Errata

DRA72x (SR 2.0, 1.0) and DRA71x (SR 2.1, 2.0) SoC for Automotive Infotainment

Figure 2-1. Simplified SoC 192-MHz Mode DLL Block Diagram

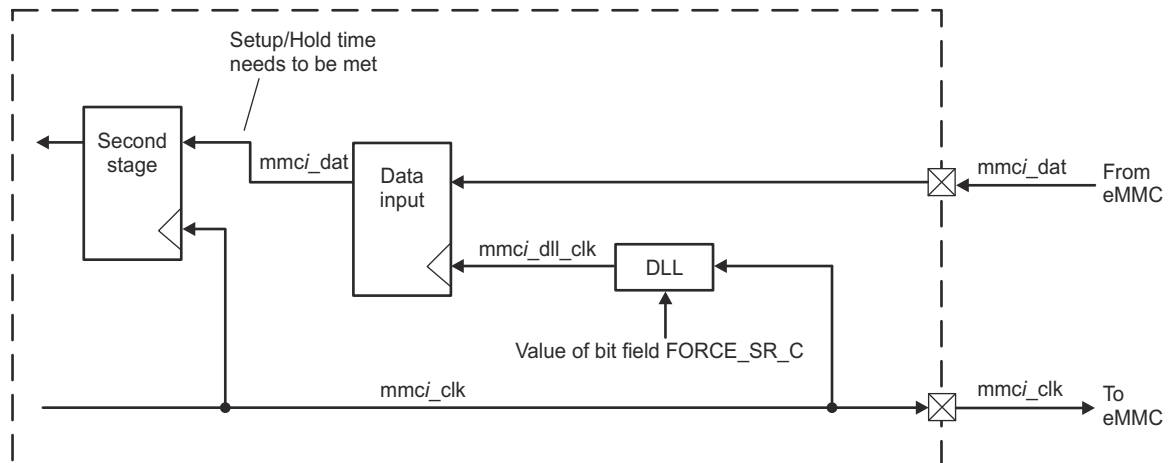
Internal to the MMC module, a second stage latch is used to recapture data captured by DLL delayed clock, `mmc_i_dll_clk`. The second stage latch captures with the original transmitting clock, `mmc_i_clk`.

`mmc_i_dll_clk` and `mmc_i_clk` both run at the same clock frequency. This results in a narrow range of tuning ratio elements, where the delayed `mmc_i_dll_clk` comes in phase with `mmc_i_clk`. If the clocks are in phase, the data captured by the first clock violates the setup and hold time requirements needed for the second stage latch, resulting in incorrectly read data. This is known as tuning re-timing errors.

**Figure 4-1. PAB_RevA**

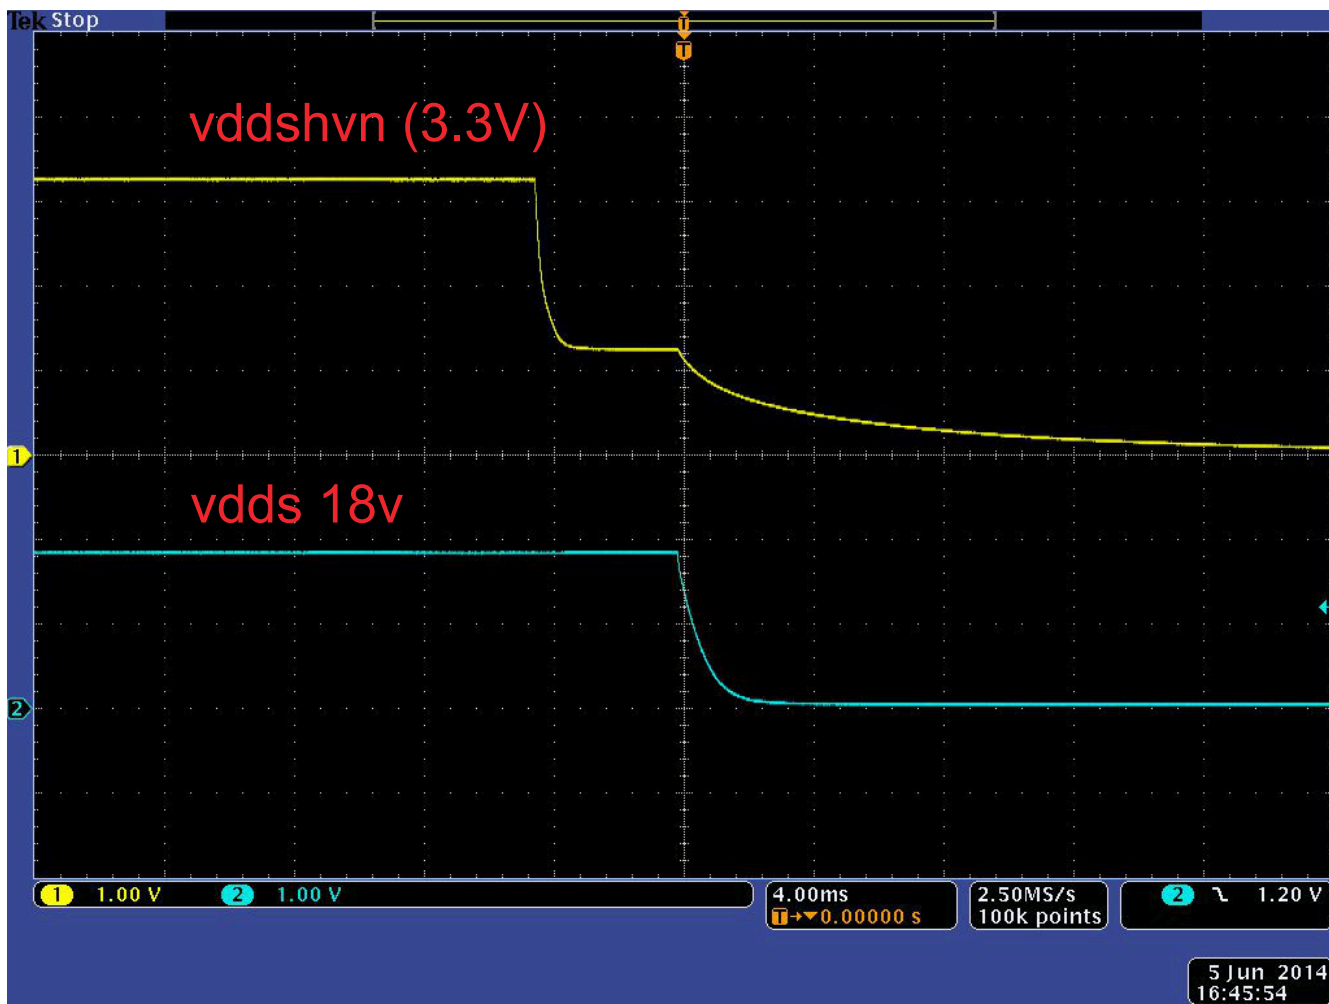
i864**VDDS18V to VDDSHVn Current Path****CRITICALITY**

For systems that use a different 3.3V supply for the SOC and connected ICs, customers should evaluate their system for reliability risk. If necessary, the PMIC OTP power-down sequence can be modified to delay the vddshv[11:1] powerdown to coincide with the vdds18v powerdown. [Note: The 3.3V rail must never be 2.0V above the 1.8V rail.]

VDDSHV8 is a special case. If VDDSHV8 is powered by the same LDO/switch as the other VDDSHVn rails then the VDDSHV8 rail can also be delayed. However, if the VDDSHV8 rail is supplied by a different LDO (e.g., LDO1 on EVM) than the other VDDSHVn rails, then the sequence should not be modified.

Figure 4-2. Leakage Voltage

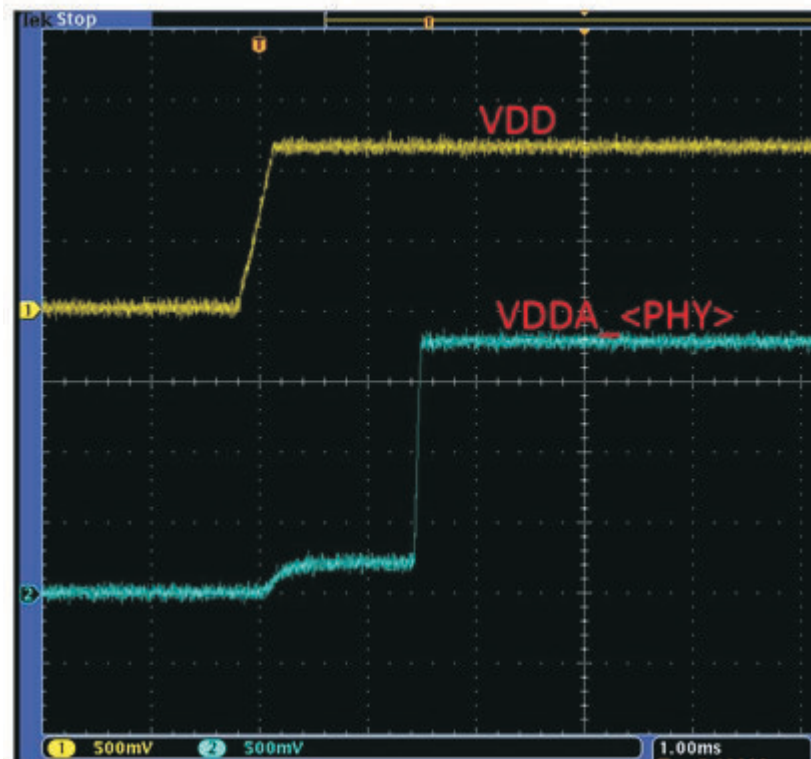
The device-specific Data Manual requires Core AVS rail (VDD) to power up before the 1.8 V high speed analog PHY domain(s). When this sequence is followed, the high speed analog PHY domain will have a small step-up to a voltage plateau (< 0.5 V) that aligns to the beginning of the VDD ramp-up, and is maintained until the ramp-up of high speed analog PHY rail, as shown in [Figure 4-2](#). Note the leakage value will differ from system to system, but will be less than 500 mV. The leakage voltage in the provided capture is approximately 250 mV.

A similar condition exist during supply power down sequence. The high speed analog PHY domain(s) are required to be powered down prior to Core AVS rail (VDD), and may cause a small plateau to exist until Core AVS rail (VDD) is ramped down.

Figure 4-3. Original Power-Up Sequence

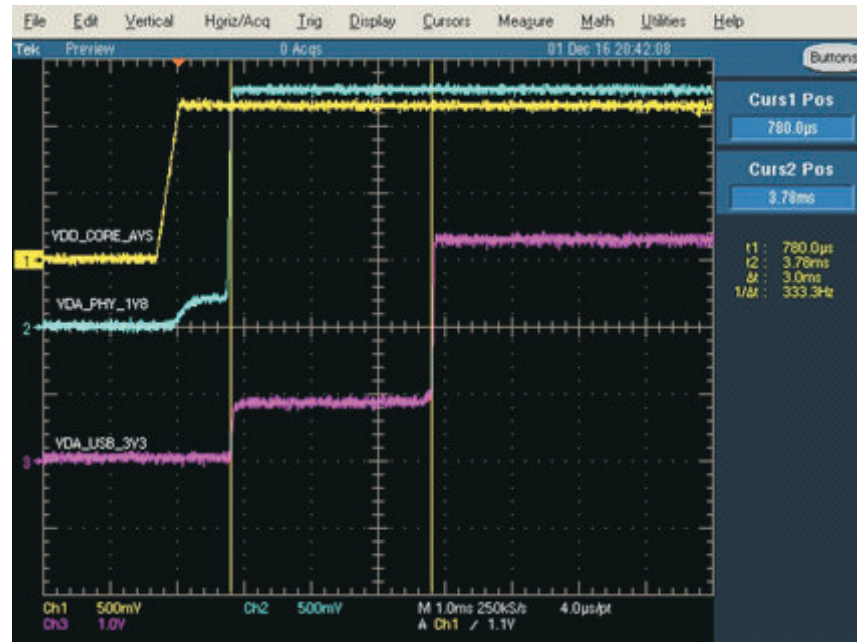
An unintended leakage current path between VDDA_PCIE (1.8 V) and VDDA33_USB1 (3.3 V) due to ESD protection diode connection across the signal to I/O supply pads exists. This path can allow current to flow from VDDA_PCIE to VDDA33V_USB1. The current flows whenever the voltage level on VDDA_PCIE exceeds VDDA33V_USB1 by more than a diode drop during certain power-up and power-down sequences.

This leakage current causes the un-energized VDDA33V_USB1 to rise to a ~1 V plateau (see [Figure 4-3](#)) due to the power resource's "off impedance" seen between the VDDA33V_USB1 power rail to ground. When the minimum "off impedance" is $\geq 100 \Omega$, the SoC leakage current is small and sustainable with no SoC reliability impacts.

Note: [Figure 4-3](#) shows in VDA_PHY_1V8 rail a plateau approximately 250 mV documented in i931, VDD to VDDA_"PHY" Current Path.

TI recommended Power Delivery Networks (PDNs) could have multiple different PMIC LDO power resources connected to the VDDA33V_USB1 rail. The LP8733/32 PMICs have a minimum OFF resistance equal to 150Ω so a PDN using these PMICs would not exceed safe leakage current level and could continue to use the original SoC power sequences. However, the TPS65917/919 PMICs have a minimum OFF resistance equal to 30Ω and would exceed the safe leakage current limit. As a result, any PDN using TPS65917/919 PMICs must implement the revised power sequencing as shown in DM version D or later. The specific sequence changes are:

The following PMIC OTP IDs have been aligned to the revised power sequencing to avoid any leakage current:
